Application for Licence Amendment

Licence Number	L8578/2011/1
Licence Holder	Regis Resources Limited
ACN	009 174 761
File Number	2011/003002-1
Premises	Duketon Gold Project

Date of Report	23 April 2024
Proposed Decision	Revised licence granted

Figure 3: Proposed TSF4, tailings and return water lines and monitoring bore locations

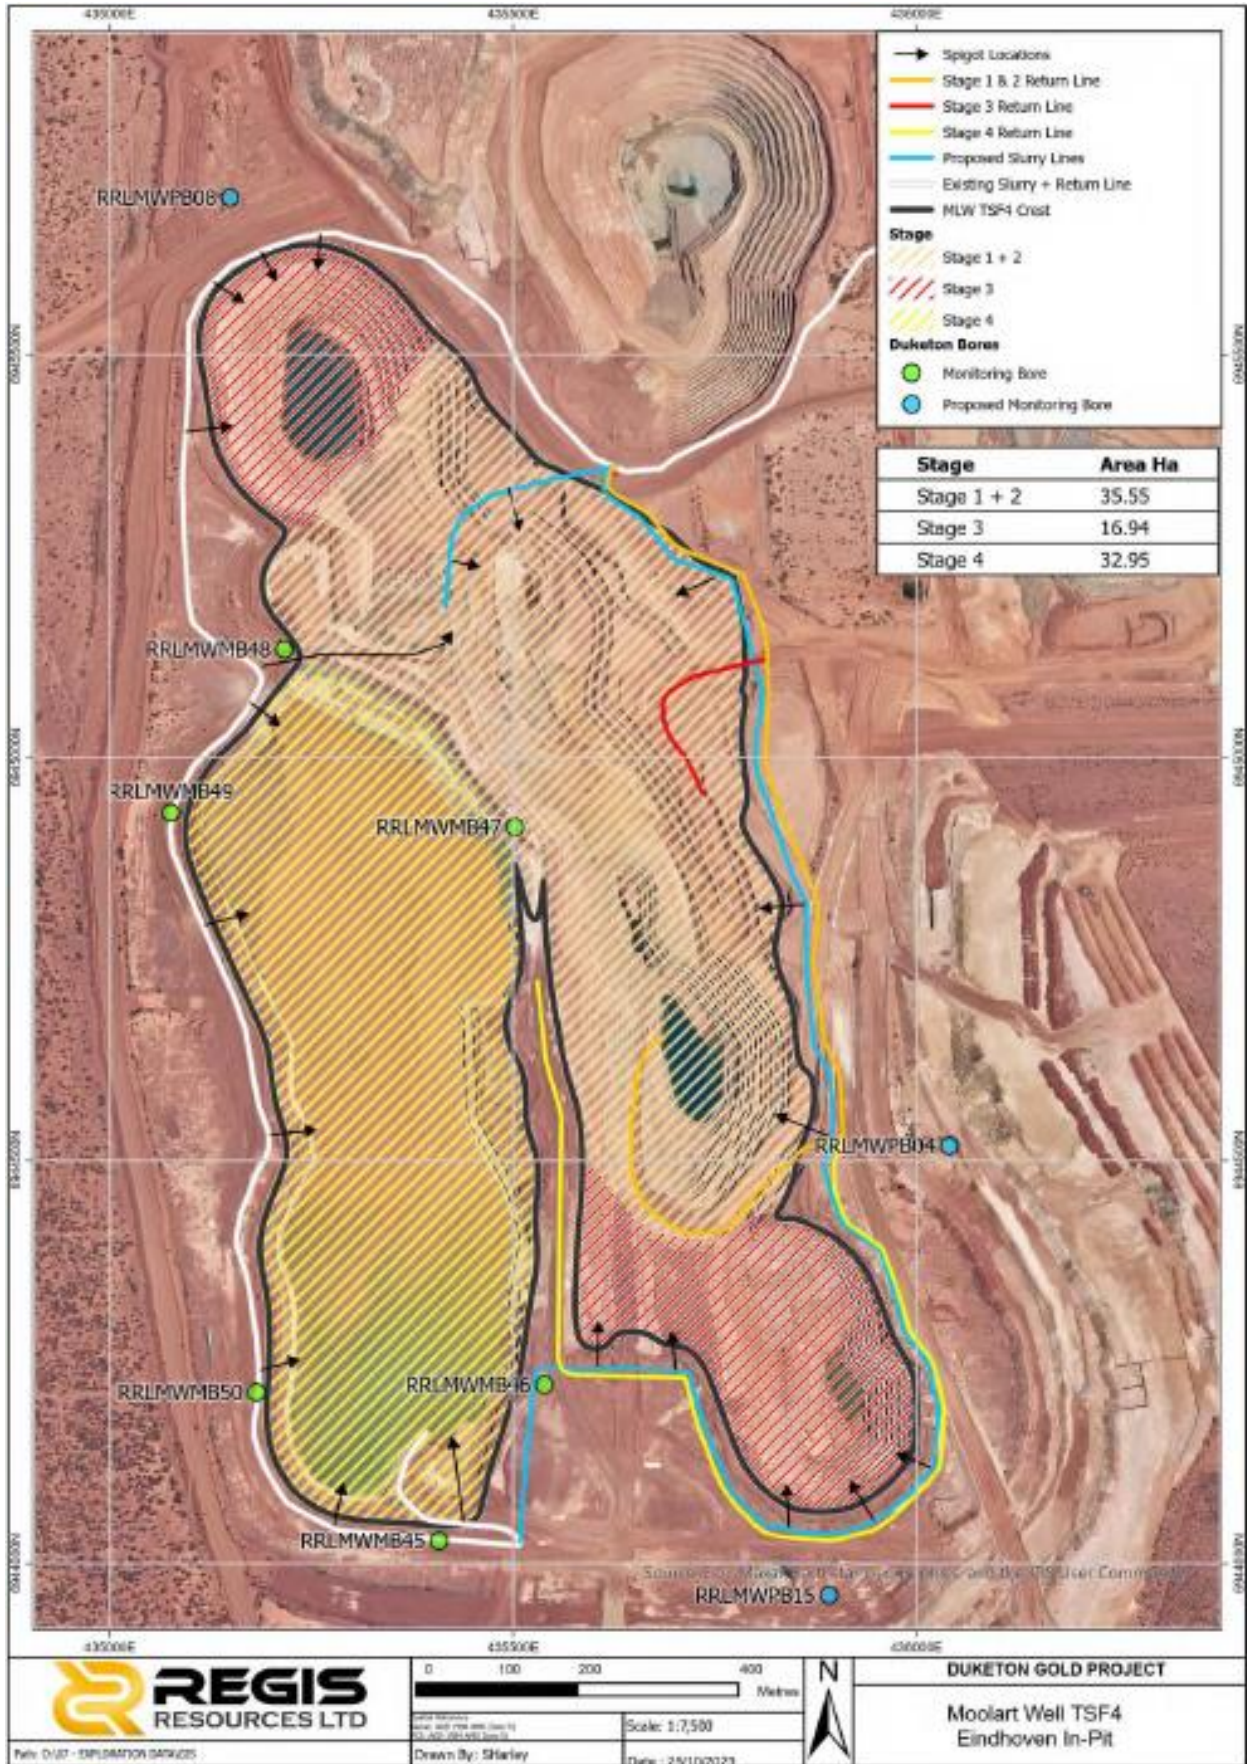
There are currently six groundwater monitoring bores specified in the existing licence for monitoring around MLW TSF2. With the establishment of MLW TSF4, the Licence Holder is proposing to add an additional three existing monitoring bores to complement the existing bore network around MLW TSF2. Bore RRLMWMB047 will require decommissioning as it is within the MLW TSF4 footprint.

CSB considers that the number of monitoring bores and their spatial distribution around the footprint of the TSF is reasonable and has recommended a suite of analytical parameters for the monitoring bores:

Definitions	Add 'Minimum Construction Requirements for Water Bores in Australia', 'suitably qualified geotechnical engineer', 'suitably qualified hydrogeologist', 'SWL', and 'WAD cyanide' to the list of defined terms.
Table 1.2.3 - Containment infrastructure	Include MLW TSF4 as a containment point reference.
Table 1.2.5 – Infrastructure approved for construction	Added rows 5 -8, MLW TSF4 Stage(s) 1 to 4 infrastructure and design and construction requirement and location
	Added row 9, MLW TSF4 tailings delivery pipeline extension construction requirements and location.
	Added row 10, MLW TSF4 groundwater monitoring bores to infrastructure and design and construction requirements and location.
Condition 1.2.12 – Annual water balance	Clarify monthly measurement of evaporation rate in TSF pits.
Table 3.4.1 – Monitoring of ambient groundwater quality	Add reference to MLW TSF4, add monitoring bores RRLMWPB004, RRLMWPB008, RRLMWPB015, remove monitoring bore RRLMWMB047.

Add parameters to monitoring of ambient groundwater quality schedule.
Figure 17 - Map of monitoring bores around Stirling in-pit TSF	Updated figure to show proposed expansion of TSF2 / TSF4 and changes to monitoring bore network.

Figure 4: Hydrogeological profile at Moolart Well – supplied by applicant

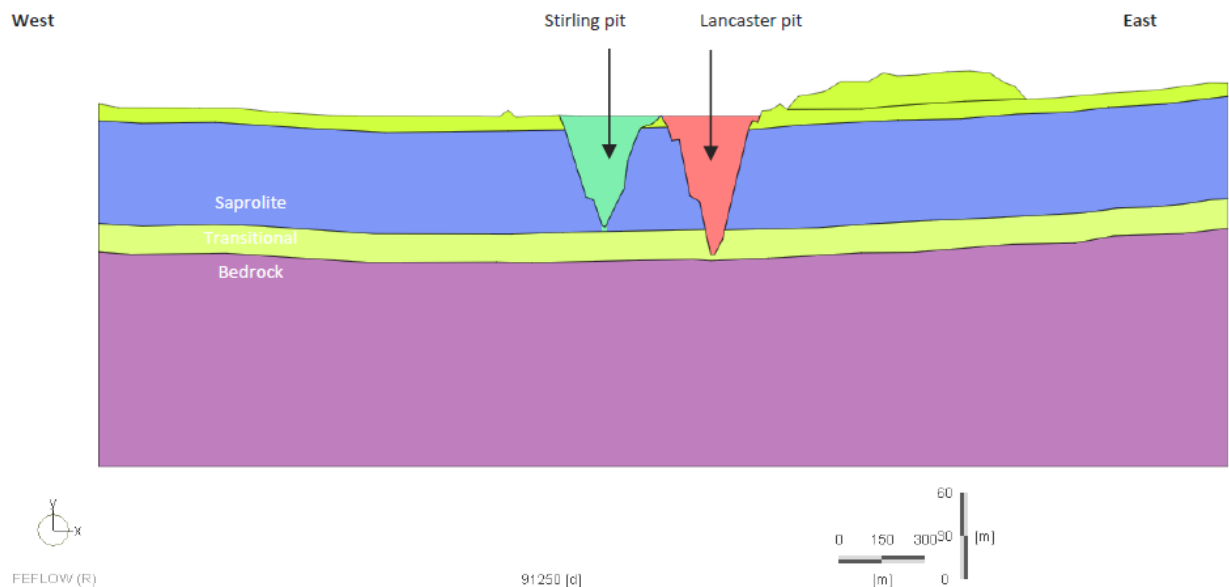
In previous modelling for MLW TSF2 the Licence Holder predicted that seepage would report from MLW TSF2 to Lancaster pit (see Figure 4). Incorporating Lancaster into MLW TSF4 it is expected that this will drive the seepage north toward the cone of depression caused by the Buckingham pit (which encompasses both the Wellington and Wallace pits).

The pathway involves either seepage migrating via the transitional zone with its relatively higher permeability than the fresh rock and saprolite zones (at Lancaster) or slower downward migration through the low permeability saprolite layer until reaching the transitional layer. This slower path reflects the shallower pit depths at Beaufort (stage 3) and Stirling (currently MLW TSF2 and stage 4 of MLW TSF4).
